BIDDING AND CONTRACT DOCUMENTS Section 00 21 15 – Addendum No. 1

SUBJECT: ADDENDUM NO. 1 TO THE BIDDING DOCUMENTS FOR

Roof Renovations Housing Authority Gallatin County 117 West Wilson Street Shawneetown, Gallatin County, Illinois 62984 HR: 390-1263

This addendum forms a part of the bidding and contract documents and modifies the bidding documents dated March 26, 2024. Acknowledge receipt of this addendum in space provided on Bid Form. FAILURE TO DO SO MAY SUBJECT BIDDER TO DISQUALIFICATION.

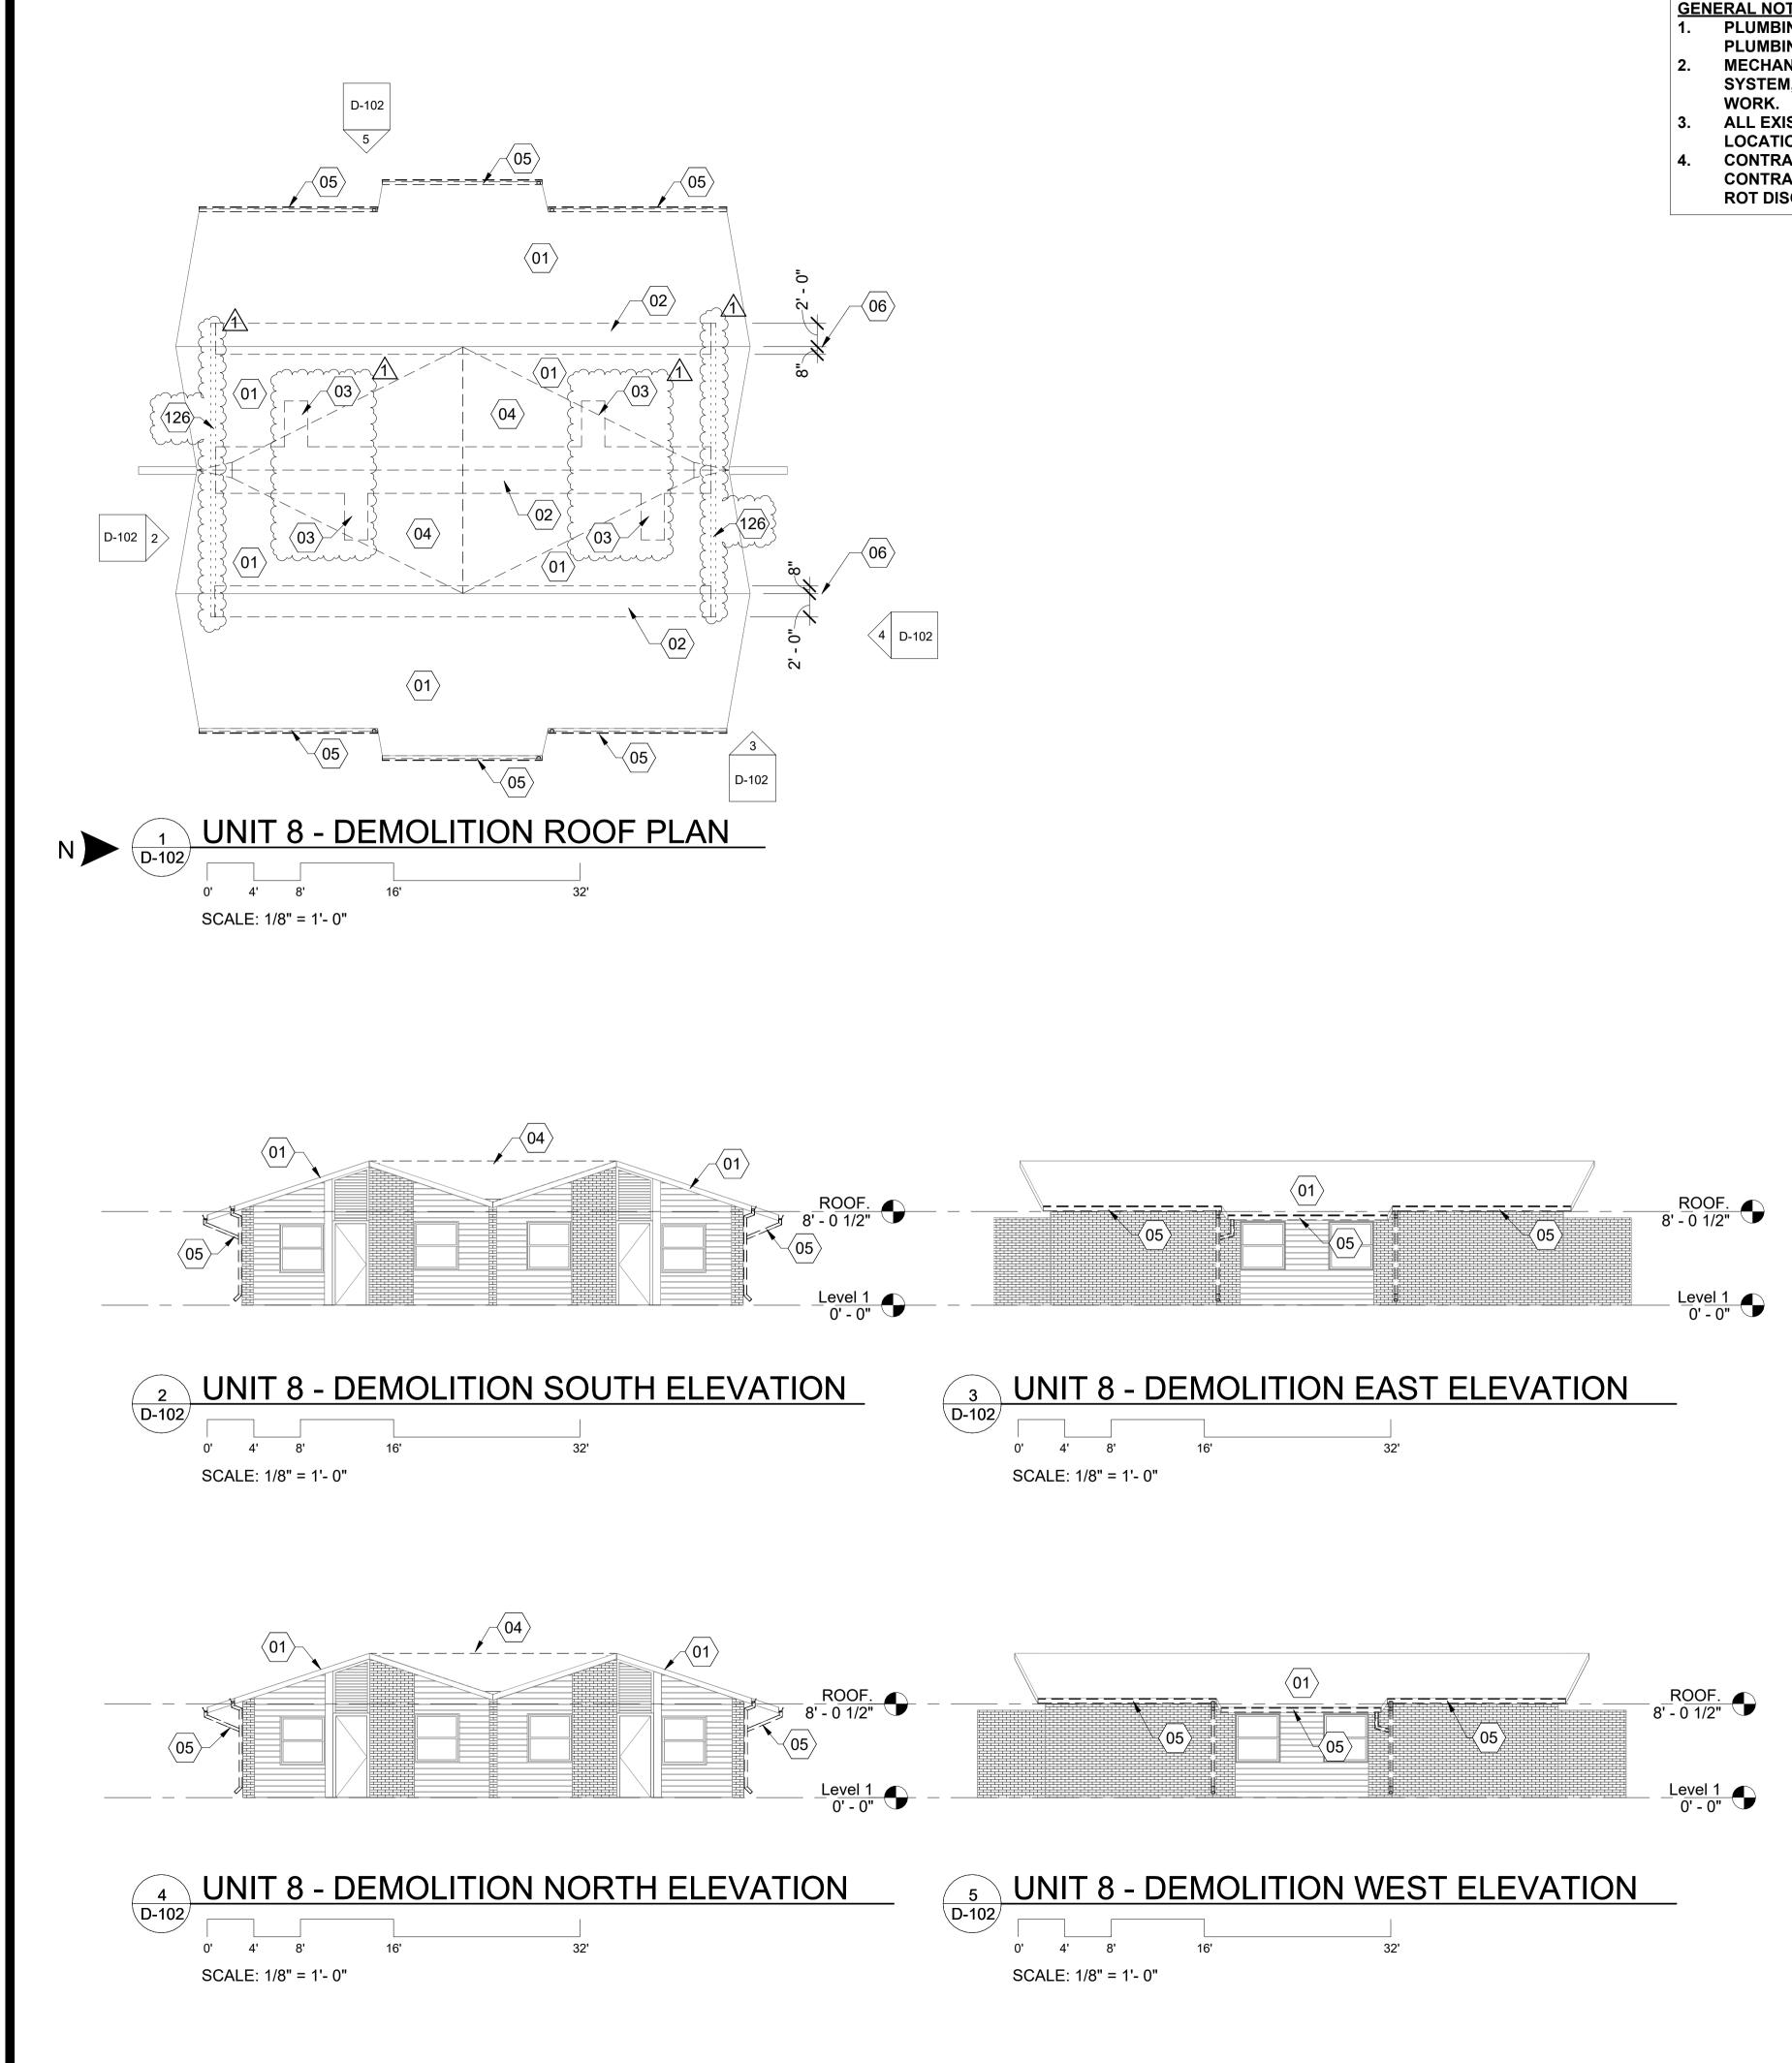
- 1. At Sheet G-103 (included), Drawing 1, Ridgway Site Plan note modifications to Staging Areas.
- 2. At Sheet **D-101** (included), Drawing 1, Demolition Roof Plan, note modified length of sheathing removal and additional cut openings to side access locations. Additional note on new wall location for reference with demolition and modification to a note for sheathing removal.

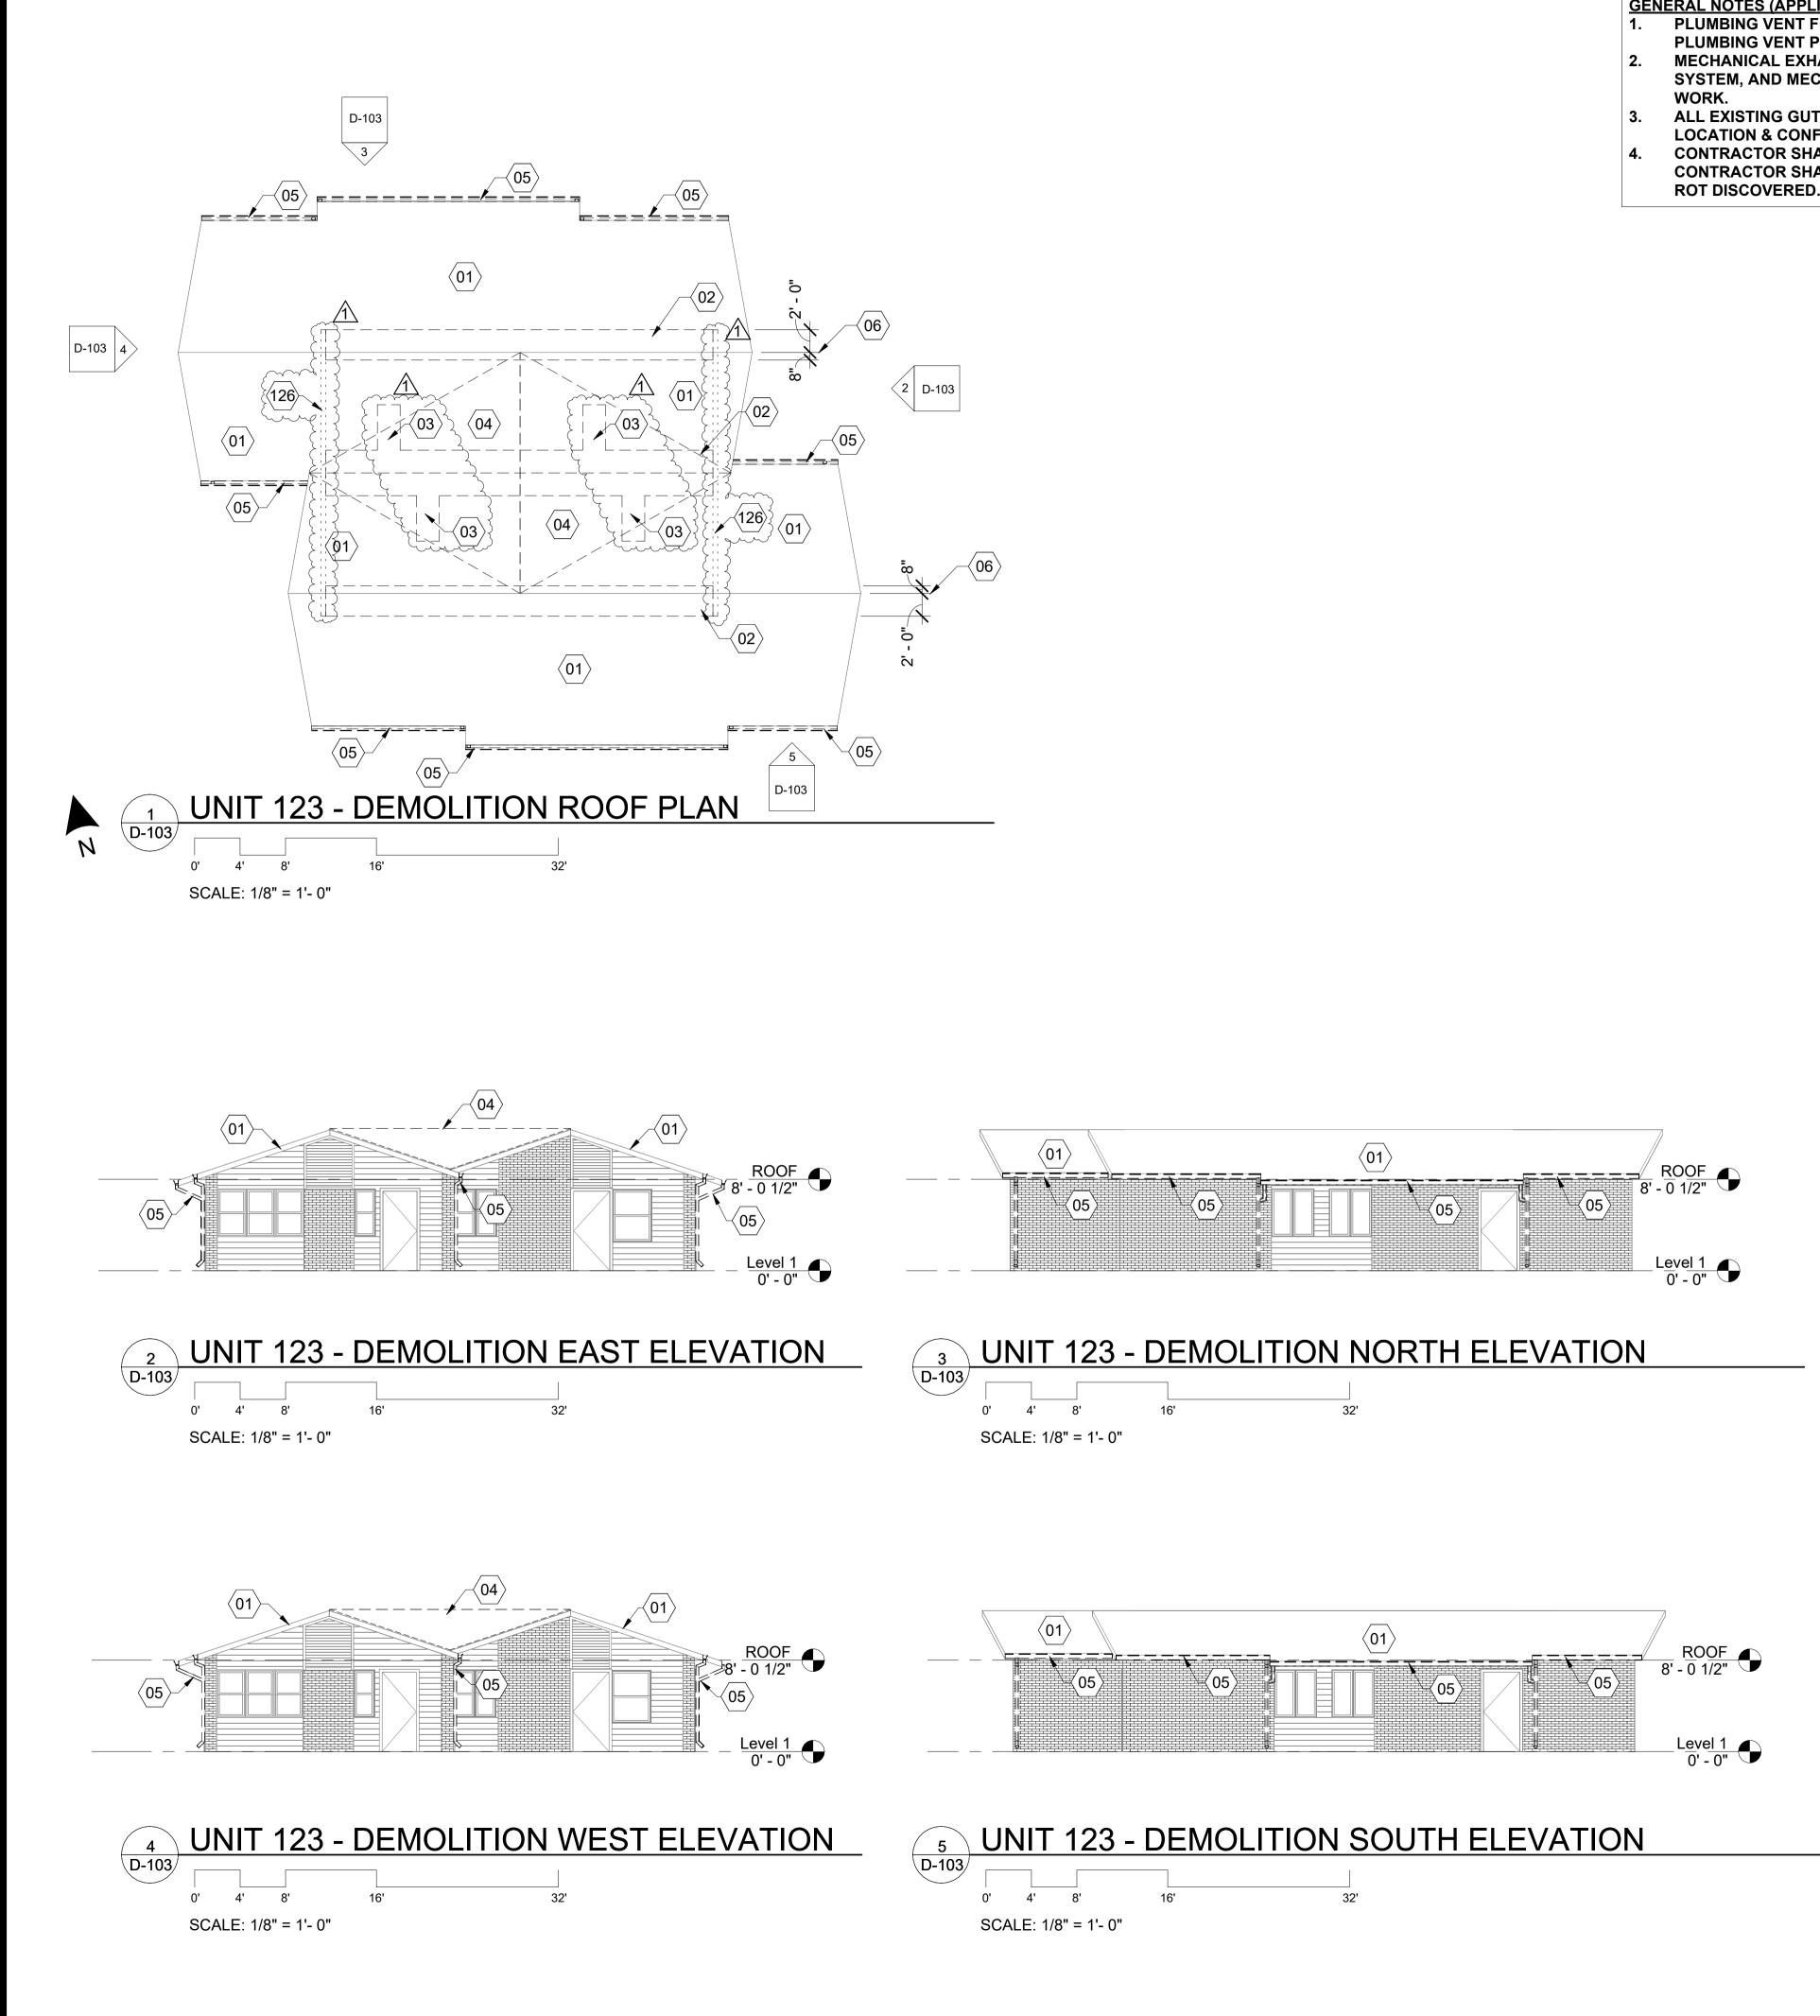
- 3. At Sheet **D-102** (included), Drawing 1, Demolition Roof Plan, note additional cut openings to side access locations. Additional note on new wall location for reference with demolition and modification to a note for sheathing removal.

ROOF RENOVATIONS	HOUSING AUTHORITY GALLATIN COUNTY RIDGWAY LINIT 5 & LINIT 8 SHAWNFFTOWN LINIT 123	S Z
MARK		DESCRIPTION
<u>_1</u>	04.19.2024	ADDENDUM #1
PROJE DESIG KGT UNI ELE	сім Г 5 - RC	90-1263 .WN: CHECK:
	Δ_1	101

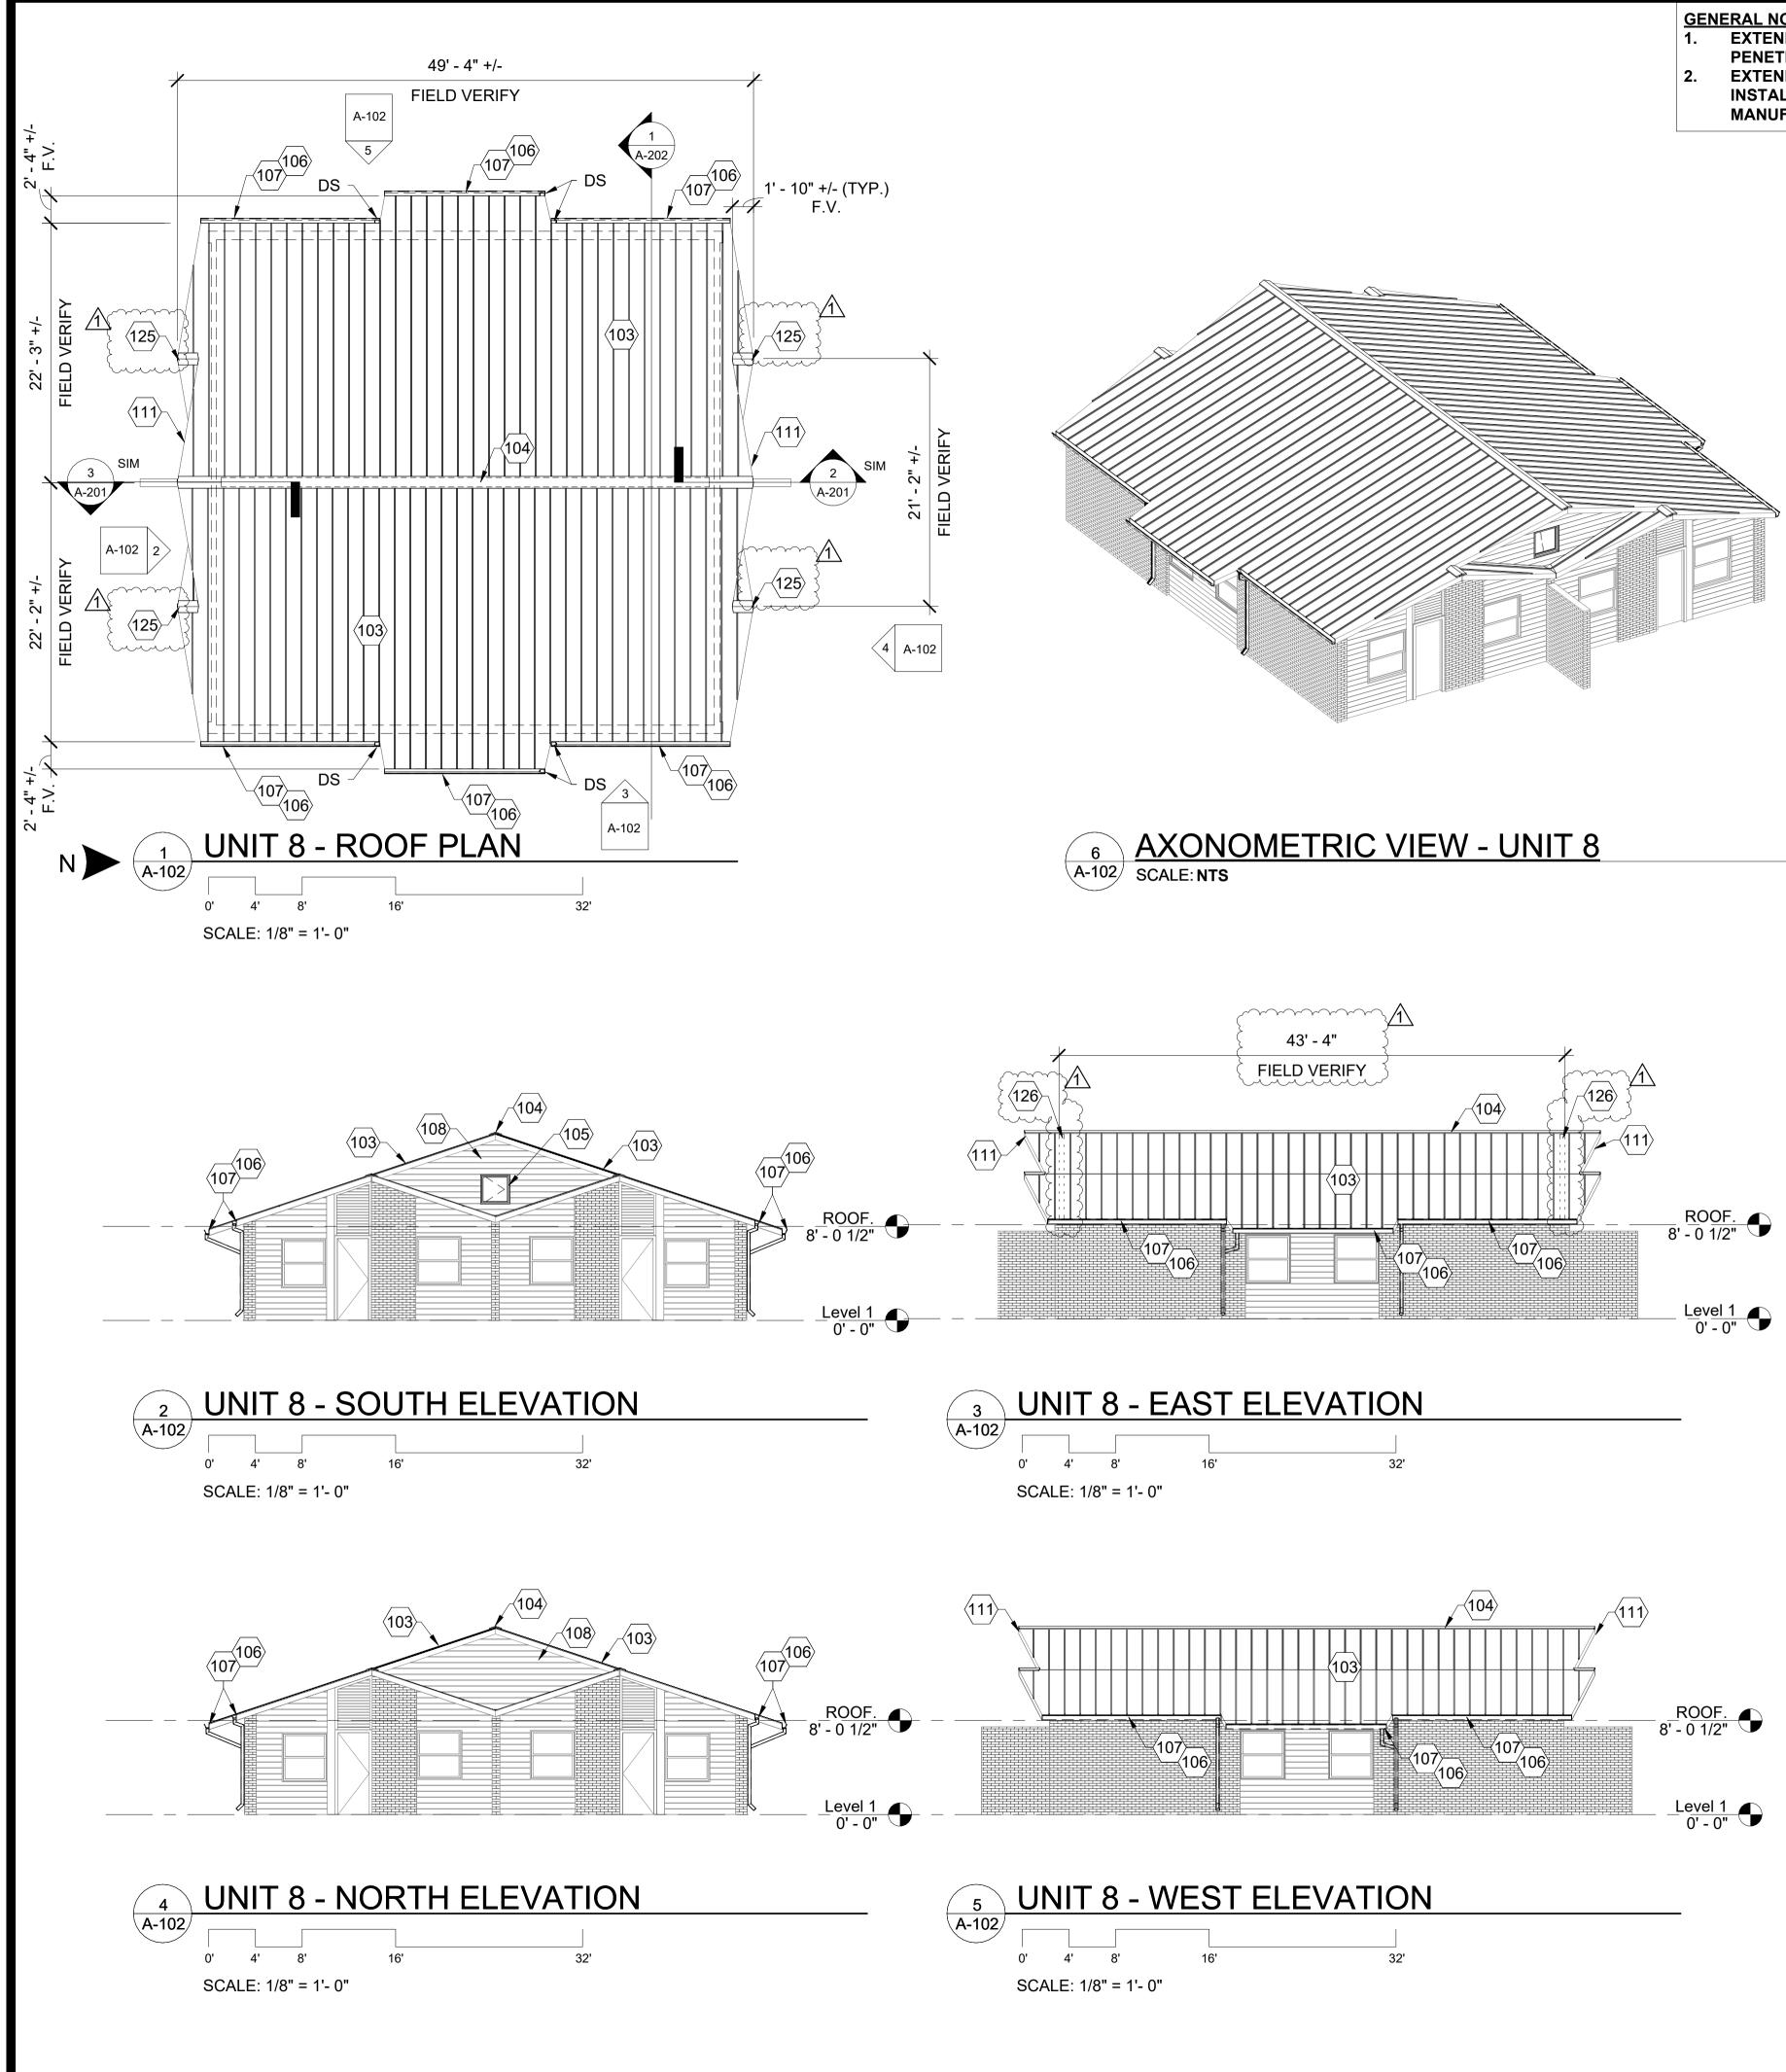
- d. New end gable outrigger framing shown.
- At Sheet A-101 (included), at Drawing 1, Roof Plan, see new note for sheet metal ridge cap. At Drawing 3, North Elevation, see note on new end walls including their location and the dimension between them (to be field verified locate per note).
